TRANSNUCLEAR WEST
STANDARDIZED NUHOMS[®] SYSTEM
NUHOMS[®]-61BT
DRY SHIELDED CANISTER
SAFETY EVALUATION REPORT

**SAFETY EVALUATION REPORT
ADDITION OF THE NUHOMS®-61BT DRY SHIELDED CANISTER
AND ADDITIONAL FUEL TYPES**

**DOCKET NO. 72-1004
MODEL NOS. STANDARDIZED NUHOMS®-24P, -52B, AND -61BT
TRANSNUCLEAR WEST, INC.
CERTIFICATE OF COMPLIANCE NO. 1004**

NUHOMS®-61BT Dry Shielded Canister
Figure 1

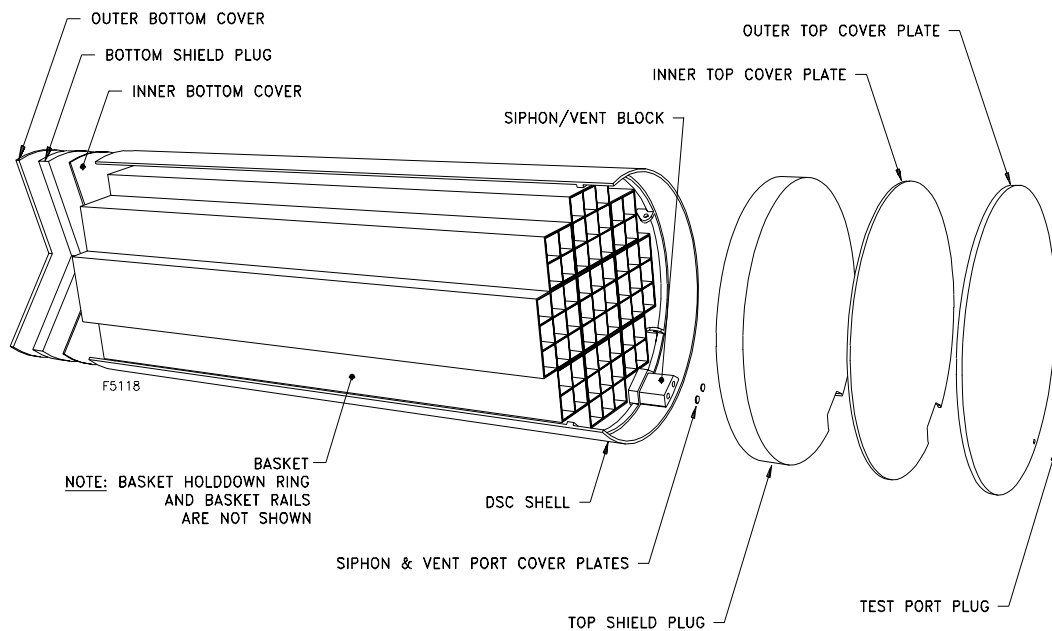
The NUHOMS®-61BT DSC, shown in Figure 1, is a new DSC design which consists of a fuel basket and canister body. Borated aluminum, boron carbide/aluminum metal matrix composite, or Boral® plates provide criticality control and heat conduction paths from the fuel assemblies to the cask wall. The canister shell thickness has been reduced from the NUHOMS®-52B by 0.125 inches to 0.500 inches and the welded closure has been upgraded to leak tight.
